Access Compliance Report

Public Rights-of-Way

Intersection ID: 43676	Main Street: SARDIS_COMMONS_LN	Cross Street: SARDIS_RD	Location: SE
ADA ID: A1CC0E6B7BFB	Ramp Type: PerpDiag	Initial Pass/Fail: Fail	Overall Compliance: No
		Severity Score: 10

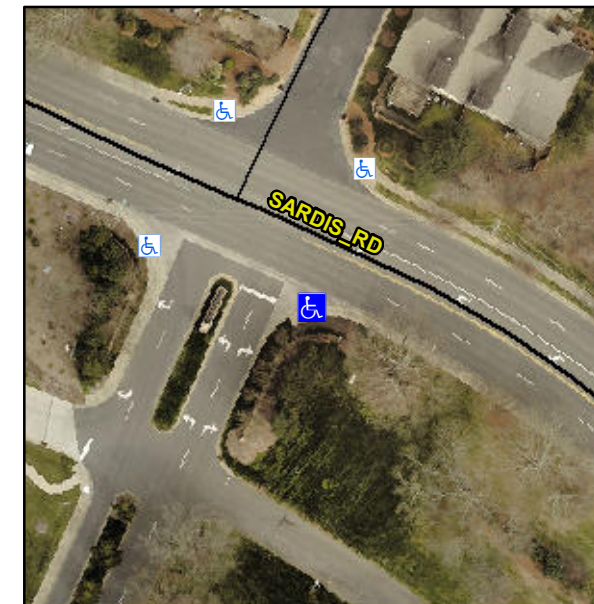
Not Found, R304.5.1, R304.5.3

Compliance	Description	Data	Compliance	Description	Data
N/A	Ramp Length (in)	63.0	Yes	Ramp Slope (%)	6.9
No	Ramp Width (in)	45.5	No	Ramp XSlope (%)	3.0
N/A	Flare Type LT	N/A	N/A	Flare Type RT	N/A
N/A	Flare Slope LT (%)	N/A	N/A	Flare Slope RT (%)	N/A
N/A	Flare Traversable LT?	N/A	N/A	Flare Traversable RT?	N/A
N/A	Landing Length (in)	N/A	N/A	DWS Provided?	N/A
N/A	Landing Width (in)	N/A	N/A	DWS Contrast?	N/A
N/A	Landing Slope (%)	N/A	N/A	DWS Length (in)	N/A
N/A	Landing X Slope (%)	N/A	N/A	DWS Full Width?	N/A
N/A	Landing Curb? (Y/N)	N/A	N/A	DWS Offset (in)	N/A
N/A	Shared Landing?	N/A			
N/A	Gutter Ponding?	N/A	N/A	Gutter Slope (%)	N/A
N/A	Gutter Lip Ht (in)	N/A	N/A	Gutter X Slope (%)	N/A
N/A	Painted X Walk1?	No	N/A	Painted X Walk2?	No
	X Walk 1 Direction	To NE		X Walk 2 Direction	To NW
N/A	X Walk 1 Width (in)	N/A	N/A	X Walk 2 Width (in)	N/A
	X Walk 1 Slope (%)	5.5		X Walk 2 Slope (%)	9.1
	X Walk 1 X Slope (%)	8.4		X Walk 2 X Slope (%)	3.0

Remove & Replace Curb Ramp With Two New Directional Ramps or Equivalent.
